D/DRC Case

3402 Earlewood Drive

Pending Certification for Bailey Bill

DESIGN/DEVELOPMENT REVIEW COMMISSION
BAILEY BILL APPLICATION
HISTORIC PROPERTY
EVALUATION SHEET
Case #2

window "G"- missing muntins will be replaced

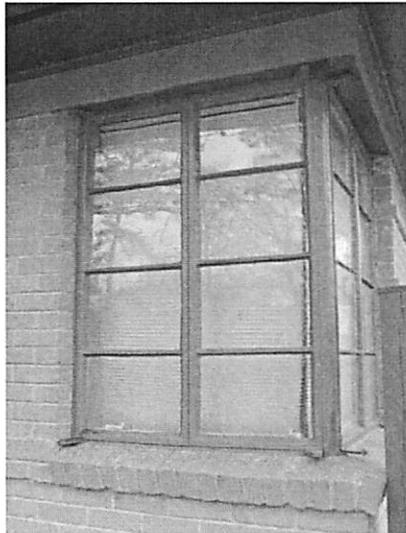
window "H" – missing muntins will be replaced

rusted hardware

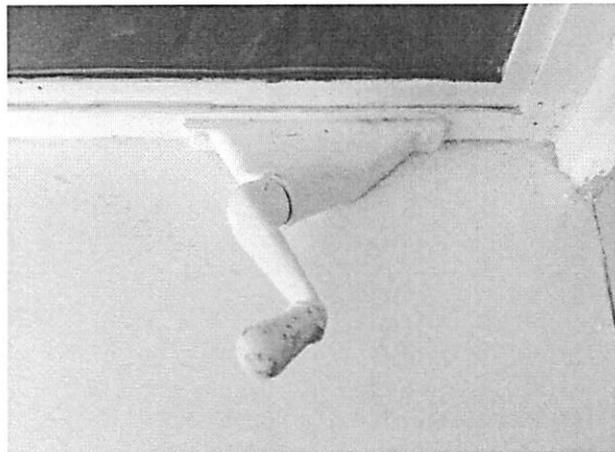
General condition of windows and hardware:

Existing window with 1/8" glass.

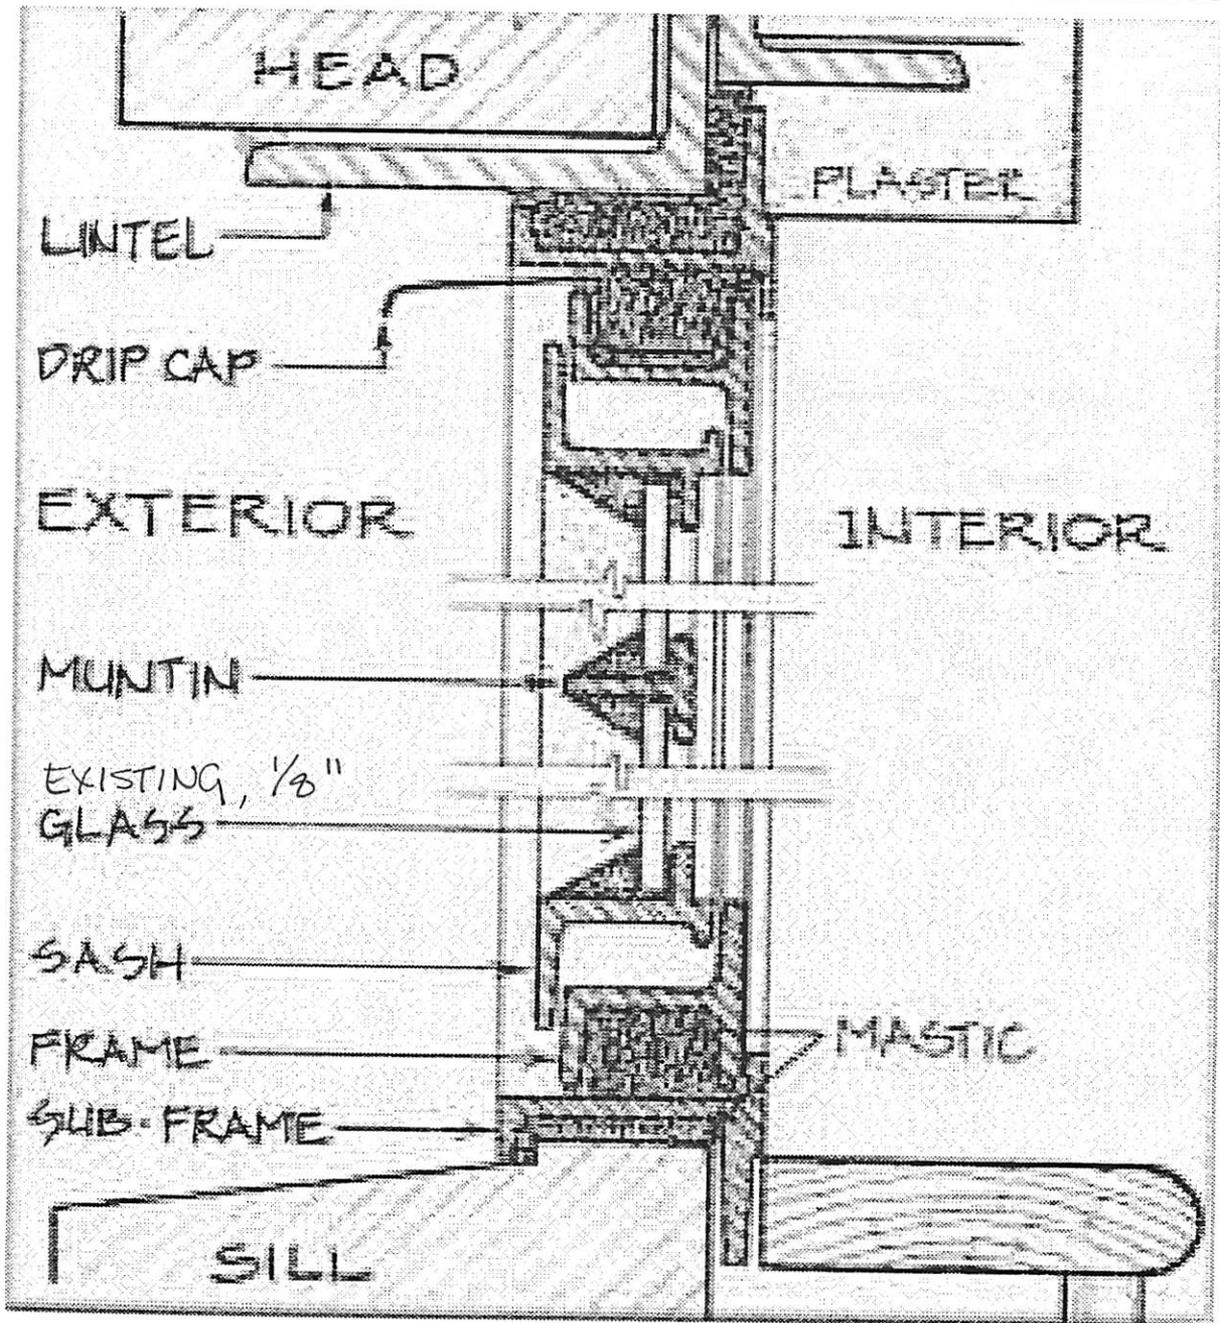
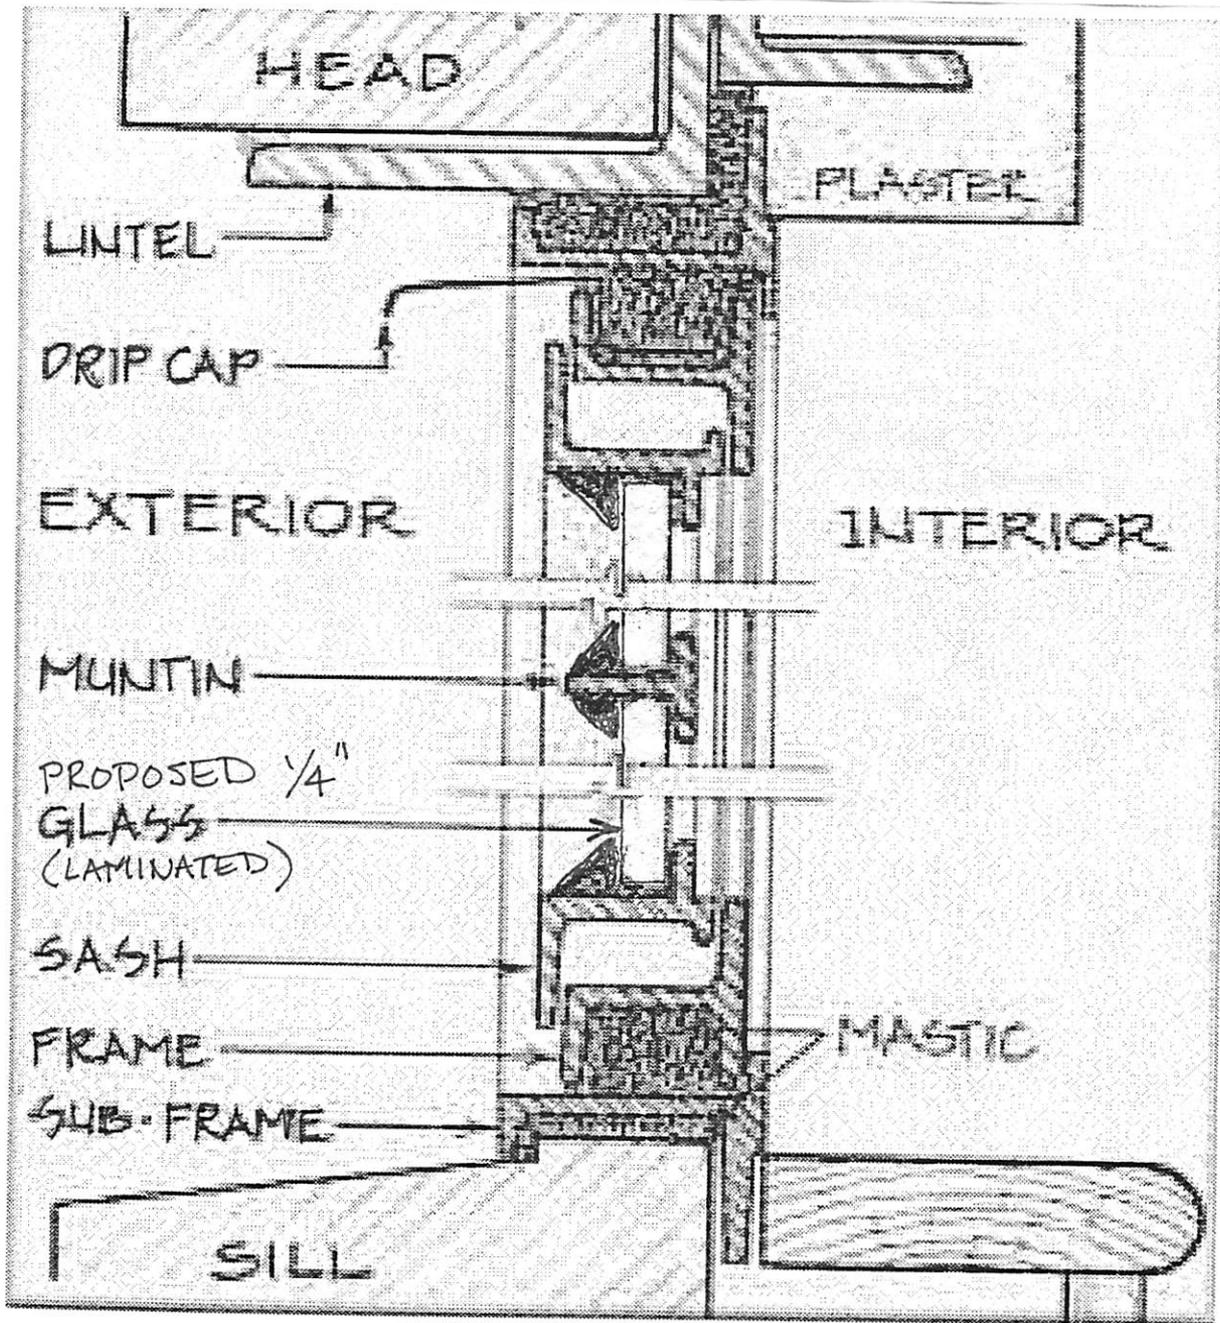
Existing section through 1/8" glass; exterior relief of 1/2"

Proposed section through 1/4" laminated glass; exterior relief of 3/8"
